# Microsystem Design

Stephen D. Senturia

## Errata

The following errors occur in the Second Printing

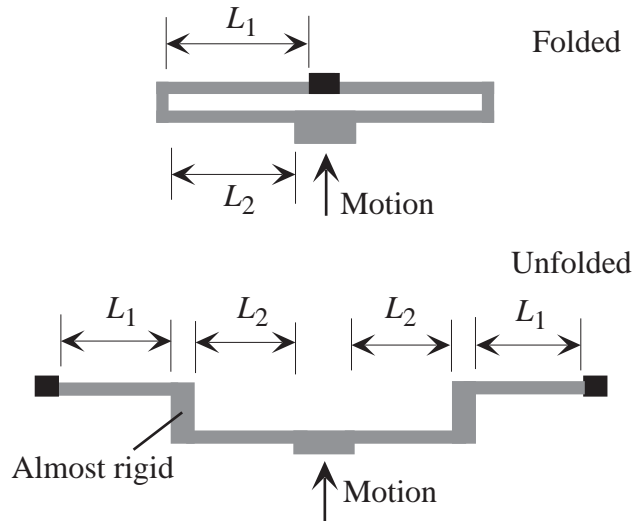
**Page 518** There is a serious error in Fig. 19.22 and the associated analysis. The unfolding of the beam as shown neglects the fact that the short folds behave as almost rigid structures. Therefore, a more accurate picture is as shown below:

**Page 519** Because of the error in Fig. 19.22, the corresponding analysis leading up to Eq. 19.20 is incorrect. The unfolded spring is, if we assume that the short folds are perfectly rigid, equivalent to two doubly supported fixed-fixed beams, one of length  $2L_1$ , the other of length  $2L_2$ . Because the two springs share a common force (effort), their equivalent circuit is in parallel. Hence, the two capacitances corresponding to the springs add. The net result is that the spring stiffness calculated in Eq. 19.20 should be

$$k = \frac{F}{c} = \left( \frac{\pi^4}{6} \right) \left[ \frac{EWH^3}{(2L_1)^3 + (2L_2)^3} \right]$$

The text that follows refers to  $2L$ , whereas it should identify both  $2L_1$  and  $2L_2$  as the lengths of the unfolded springs. Further, the lengths of  $L_1$  and  $L_2$  are estimated incorrectly from the photograph in Fig. 19.18. The stated values of  $75 \mu\text{m}$  are, more accurately, in the range  $110 - 120 \mu\text{m}$ . Interestingly enough, if  $120 \mu\text{m}$  is used, the resulting stiffness is within a few percent of the originally printed value of  $2.8 \text{ N/m}$  which resulted from the incorrect figure in combination with the incorrect lengths. Therefore, the remaining conclusions are unaffected, even though this intermediate calculation, as originally printed, was incorrect.
